Coal Combustion Waste Impoundment

Round 5 - Dam Assessment Report

Jefferies Generating Station (Site # 002)

Dewberry & Davis, LLC
Fairfax, Virginia

Appendix A - Doc 1.3 Impoundment Drawing 4007-0A

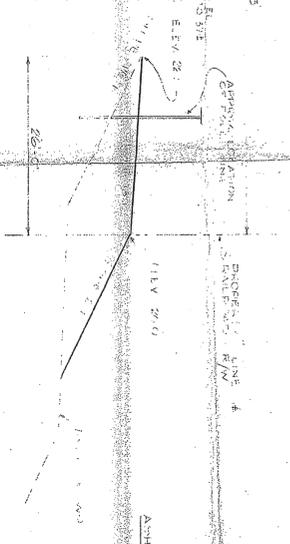
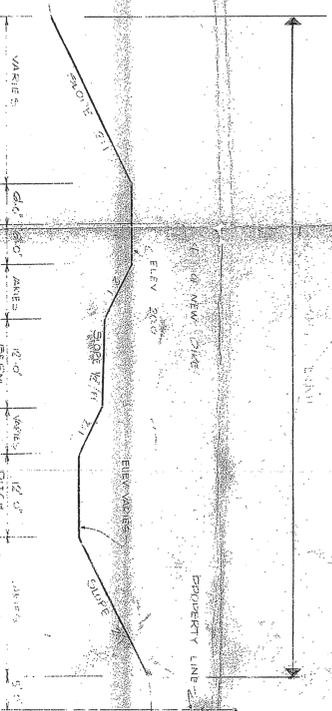
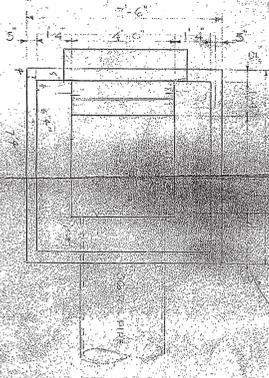
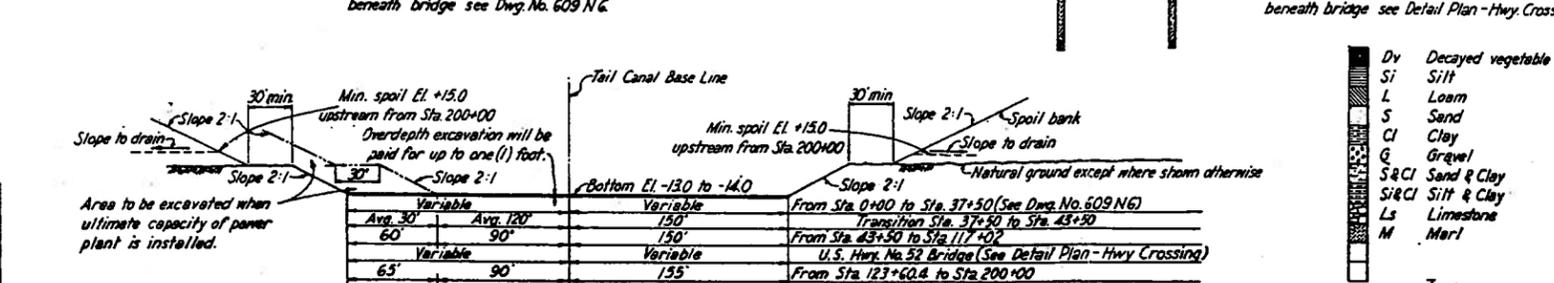
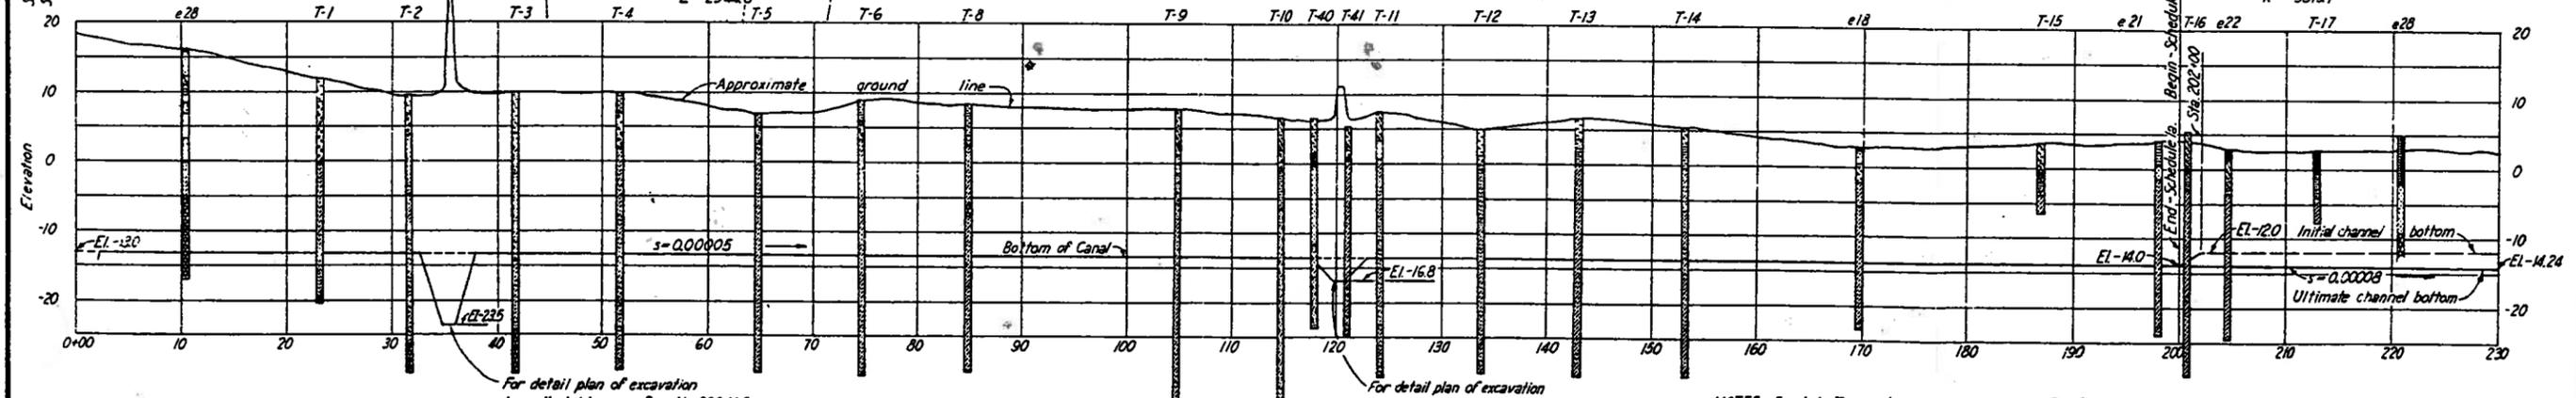
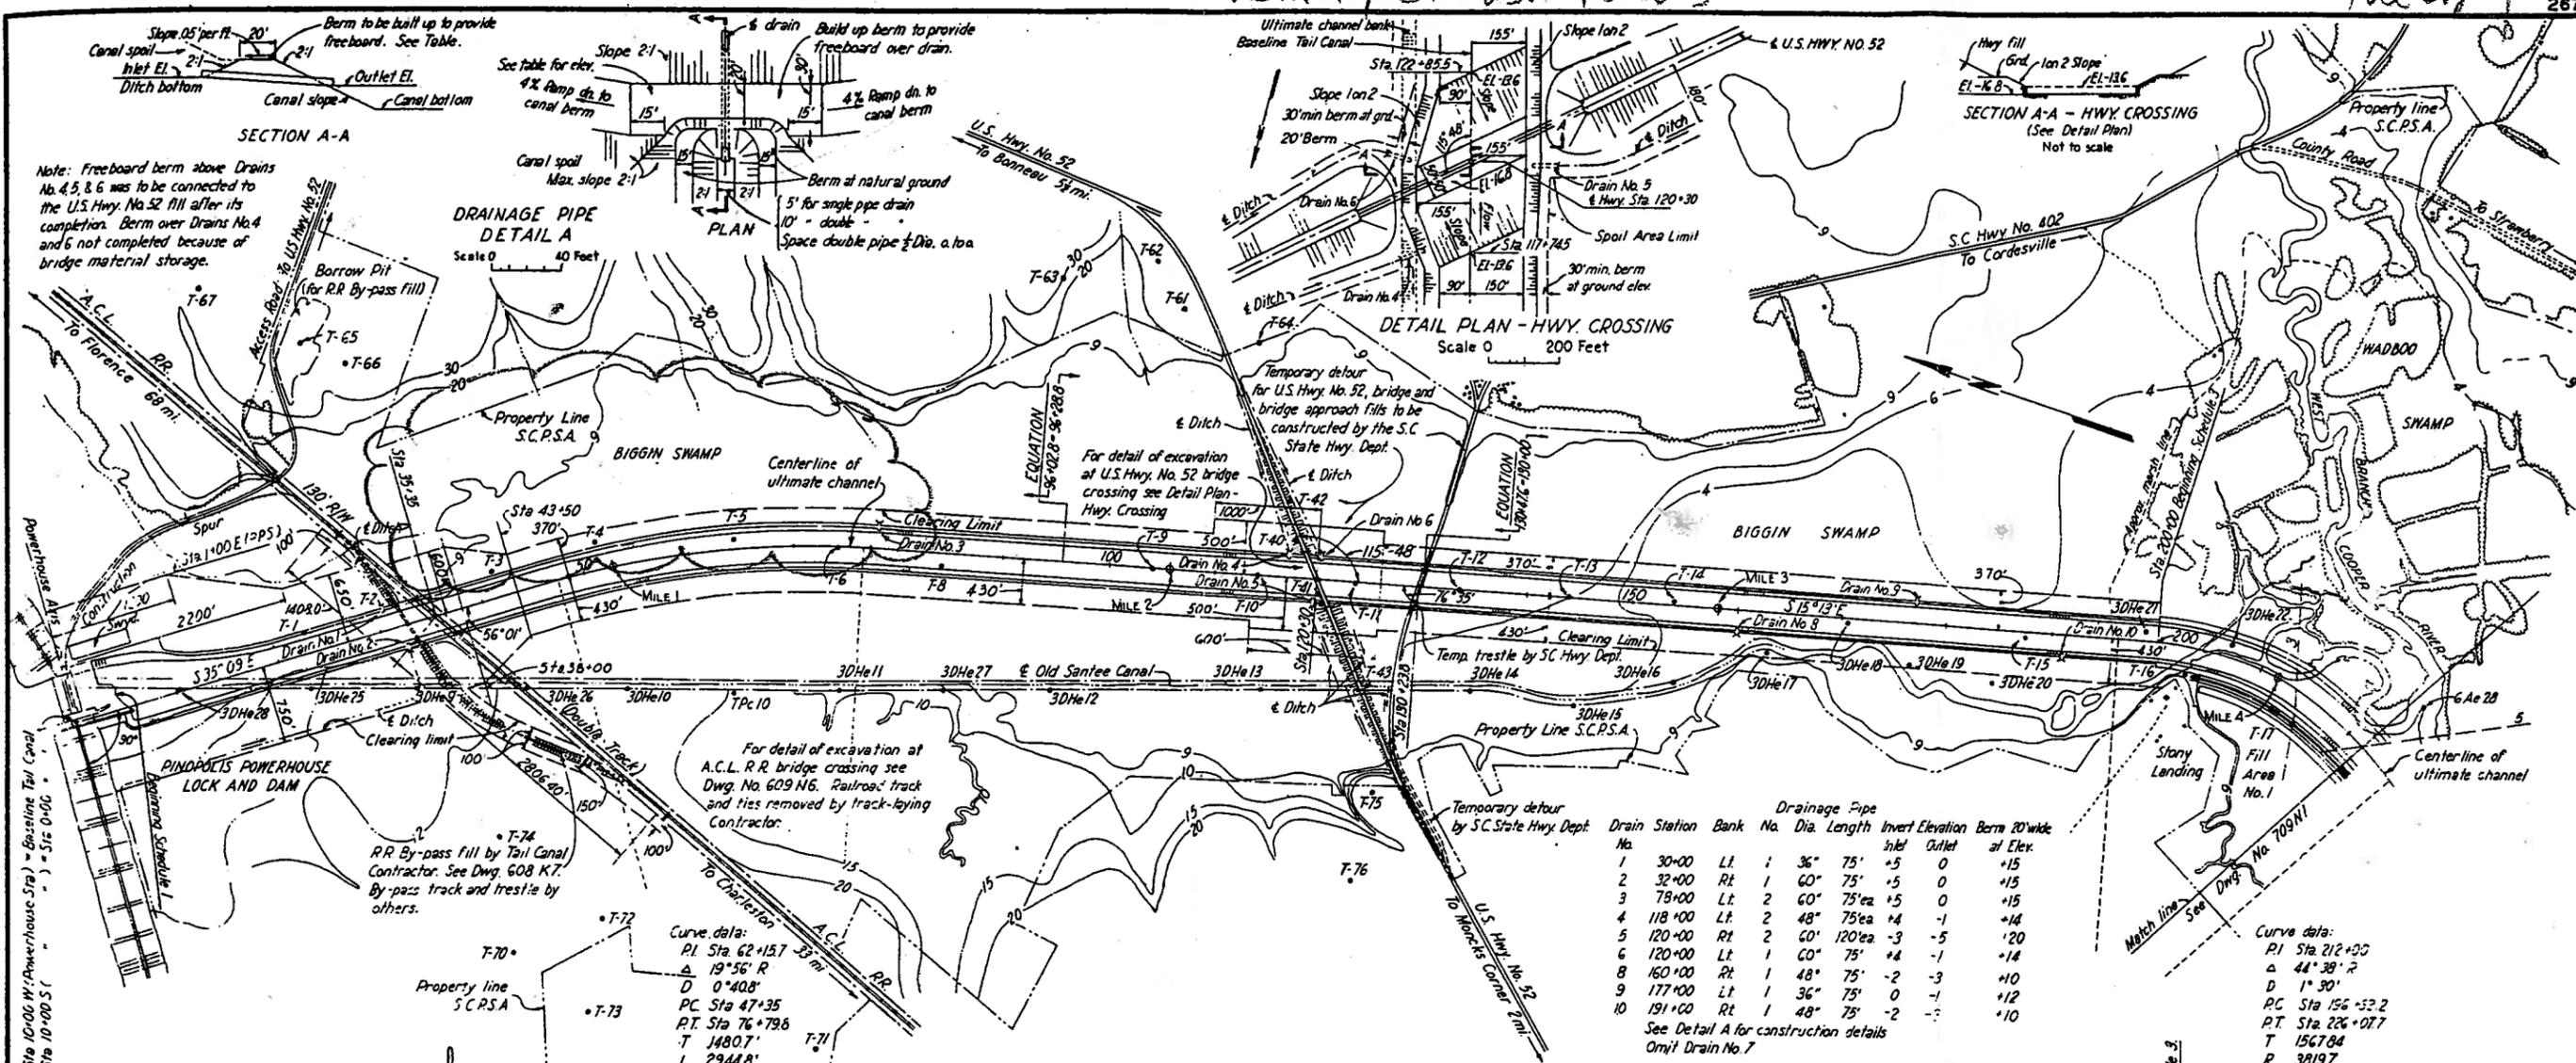
Supporting technical documents are limited. The original design documentation is limited to one drawing and does not entirely reflect visual observations in the

field. No other technical documentation about the design of the existing facility is available. Technical documents to verify the adequacy of the pond storage, outlet structures, and structural stability of the embankments are not available.

basic and apparently consisted of one drawing as shown in (Appendix A – Doc 1.3). No geometric or other design information was provided for the cross dike embankment.
